**Re: Urnfield (conditions): Application for approval of details reserved by condition 6 of appeal ref. 23/D/00018/4 | APP/Y3615/W/22/3300200 and GBC ref 23/D/00018/4**

The purpose of this letter is to make both you and the case officer aware that we have a number of serious concerns about the submitted documentation to discharge condition 6, Surface Water Drainage Scheme.

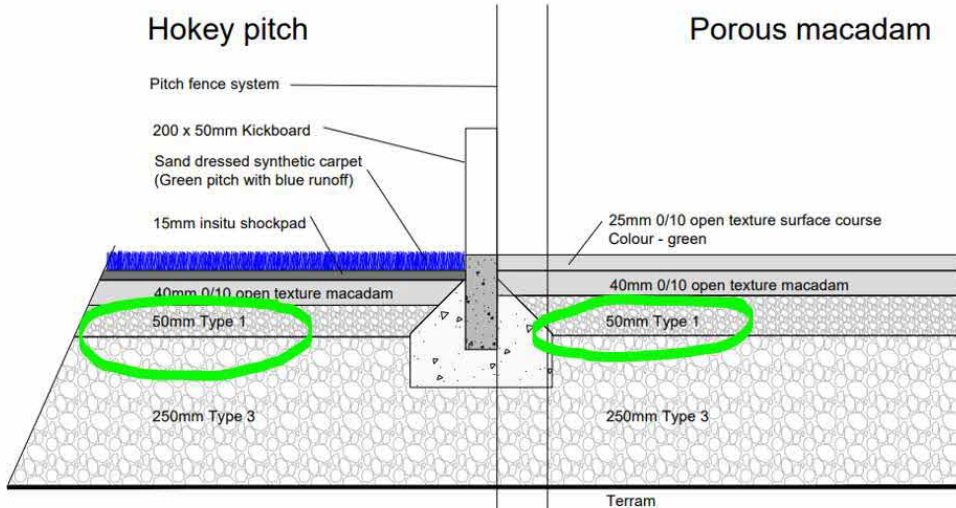
Condition 6 requirements	Summary Comment / deficiency
Evidence that the proposed final solution will effectively manage the	The current calculations underestimate the storage needed by using the FSR

1 in 30 & 1 in 100 (+40% allowance for climate change) storm events, during all stages of the development. The final solution should follow the principles set out in the approved drainage strategy. Associated storage volumes shall be provided using an infiltration-based strategy.	rather than the FEH rainfall and the drainage and the principles of the carpark drainage have changed from the outline application.
Detailed drainage design drawings and calculations to include: a finalised drainage layout detailing the location of drainage elements, pipe diameters, levels, and long and cross sections of each element including details of any flow restrictions and maintenance/risk reducing features (silt traps, inspection chambers etc.).	The calculations provided appear to use certain parameters which effectively underestimate the infrastructure needed and how the proposed construction sections will allow infiltration drainage. Additionally, the design does not contain long sections and cross sections as requested  No information around silt traps has been provided.
